Technical Service Bulletin: TSB180112

Released Date: 05-Jul-2023

New Rear Crankshaft Seal Service Tools

Figure 1, Unitized Crankshaft Seal

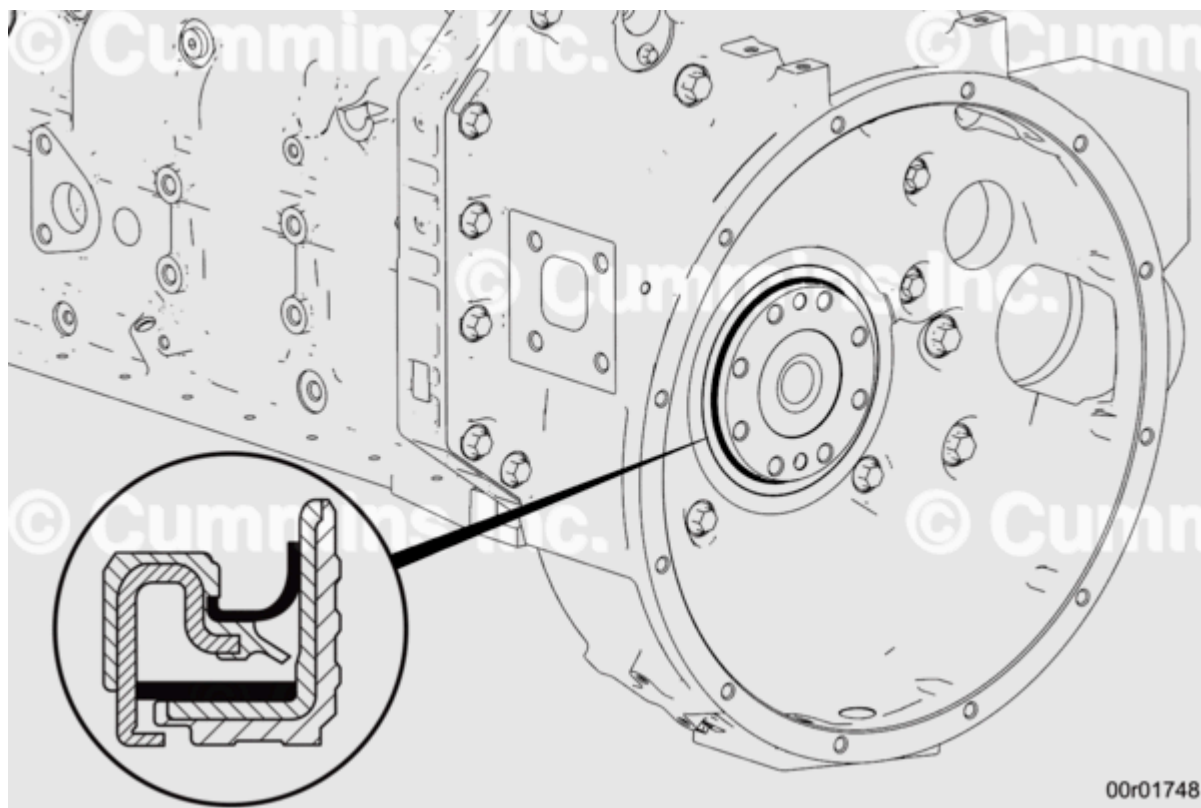
Some engines used to use a dual or non-lip style seal which utilize a built in wear sleeve and a concealed sealing lip. The inner and outer diameters are press-fit onto the crankshaft and the flywheel housing respectively. The seal is removed from the flywheel housing/seal carrier bore using required service tools, rear crankshaft seal removal kit, Part Number 3164660.

Figure 2, Lip Crankshaft Seal

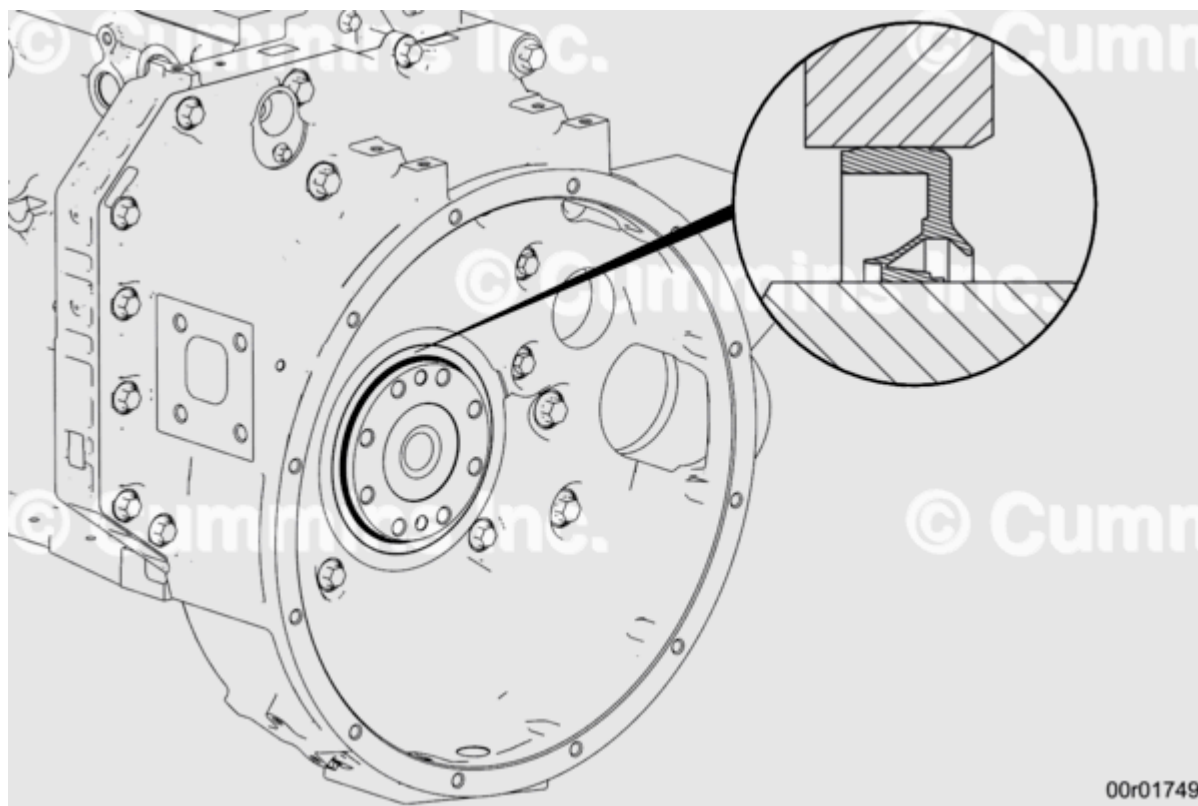
The rotating portion of the sealing occurs at the contact surface between the lip of the seal and the crankshaft. The seal is installed into the flywheel housing/seal carrier bore using required service tools, rear crankshaft seal installation kit, Part Number 5395259, and rear crankshaft seal removal kit, Part Number 5395330.
